BULLETIN

NUMBER 45

SUBJECT: Control System Interference

MODELS AFFECTED: J3

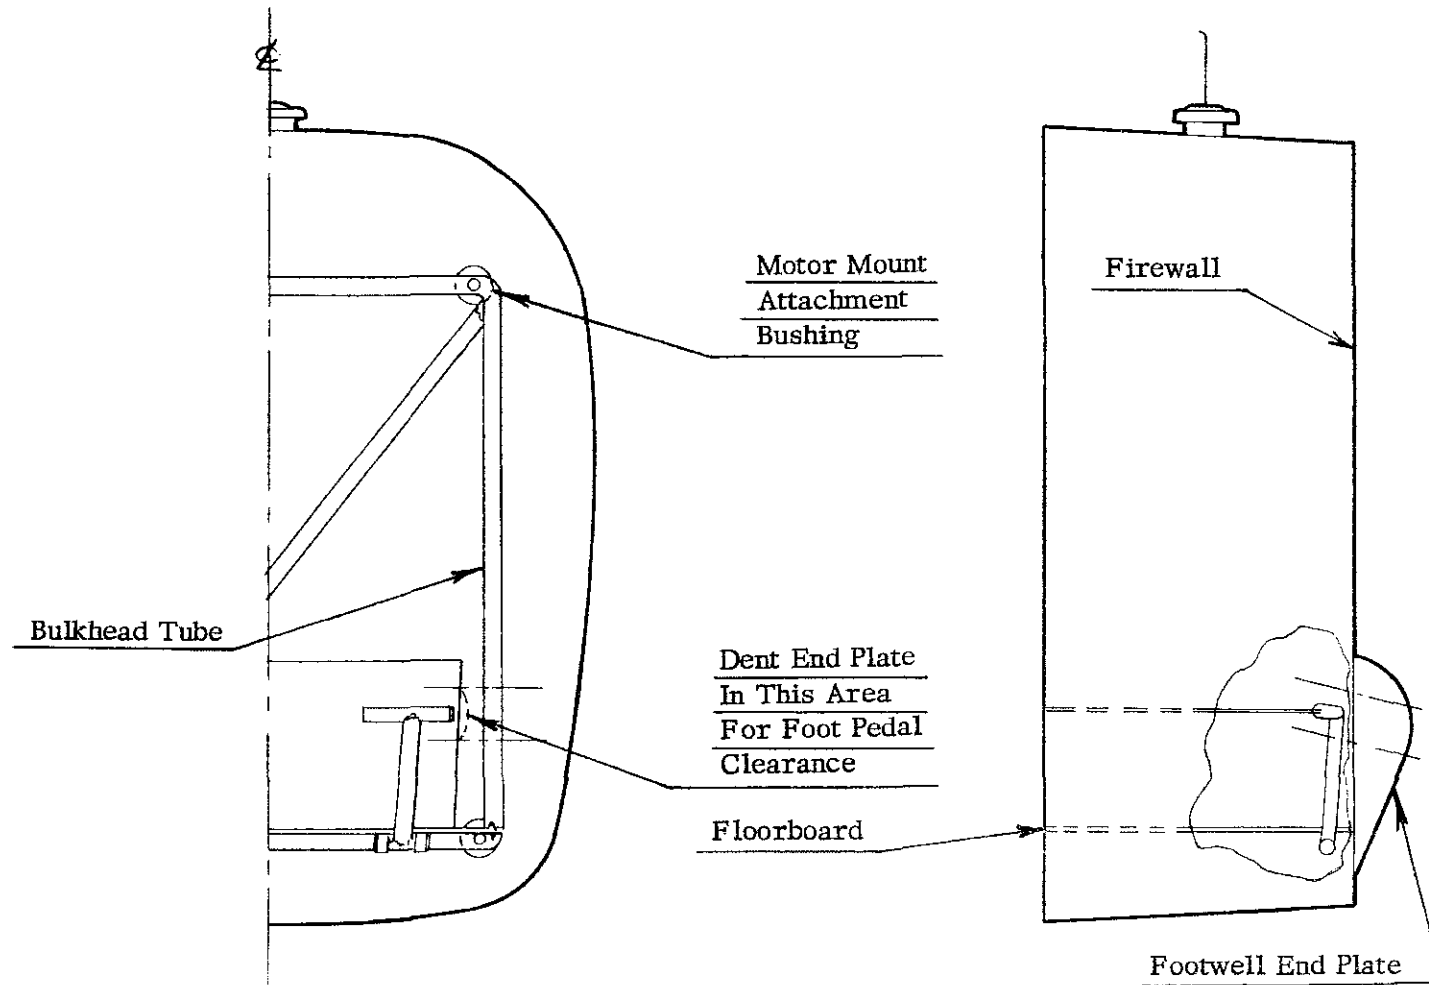
We have received reports of interference of the front rudder pedals with the fire-wall footwells. There is a possibility that the bolt attaching the cable to this pedal has been installed with the nut on the outboard side of the pedal lug. If this condition exists and if reversing the bolt position does not give a minimum of 1/4" clearance, it will be necessary to rework the footwell as shown in the attached sketch to obtain the minimum clearance.

It is requested that the clearance at this point be checked at each periodic inspection.

Note: Use Wooden or Non-Metal Mallet
Use Same Procedure On Left Side

CAUTION: DO NOT DENT BULKHEAD TUBES
